# Access Compliance Report

## Public Rights-of-Way

### (Curb Ramps)

Intersection ID: 12620	Main Street: JOHN_CROSLAND_JR_DR	Cross Street: HARGROVE_AV	Location: SW
ADA ID: 87A237C7CFC7	Ramp Type: PerpDiag	Initial Pass/Fail: Fail	Overall Compliance: No
Severity Score: 22.5			
Codes/Mitigation Info/Possible Solution		Field Measurements/Component Compliance

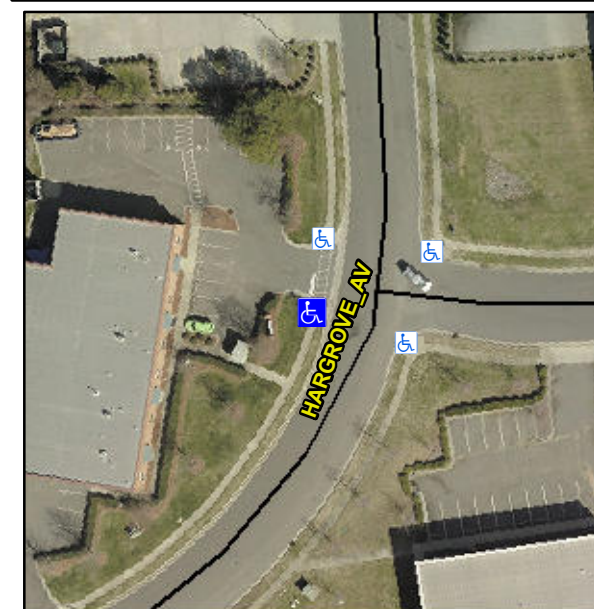
**Not Found, R304.5.1, R304.2.2, R304.5.3**

Compliance	Description	Data	Compliance	Description	Data
N/A	Ramp Length (in)	30.5	No	Ramp Slope (%)	8.9
No	Ramp Width (in)	39.0	No	Ramp XSlope (%)	5.0
N/A	Flare Type LT	N/A	N/A	Flare Type RT	N/A
N/A	Flare Slope LT (%)	N/A	N/A	Flare Slope RT (%)	N/A
N/A	Flare Traversable LT?	N/A	N/A	Flare Traversable RT?	N/A
N/A	Landing Length (in)	N/A	N/A	DWS Provided?	N/A
N/A	Landing Width (in)	N/A	N/A	DWS Contrast?	N/A
N/A	Landing Slope (%)	N/A	N/A	DWS Length (in)	N/A
N/A	Landing X Slope (%)	N/A	N/A	DWS Full Width?	N/A
N/A	Landing Curb? (Y/N)	N/A	N/A	DWS Offset (in)	N/A
N/A	Shared Landing?	N/A			
N/A	Gutter Ponding?	N/A	N/A	Gutter Slope (%)	N/A
N/A	Gutter Lip Ht (in)	N/A	N/A	Gutter X Slope (%)	N/A
N/A	Painted X Walk1?	No	N/A	Painted X Walk2?	Yes
	X Walk 1 Direction	To E		X Walk 2 Direction	To N
N/A	X Walk 1 Width (in)	N/A	N/A	X Walk 2 Width (in)	55.0
	X Walk 1 Slope (%)	3.4		X Walk 2 Slope (%)	1.7
	X Walk 1 X Slope (%)	2.4		X Walk 2 X Slope (%)	4.3

**Remove & Replace Curb Ramp With Two New Directional Ramps or Equivalent.**
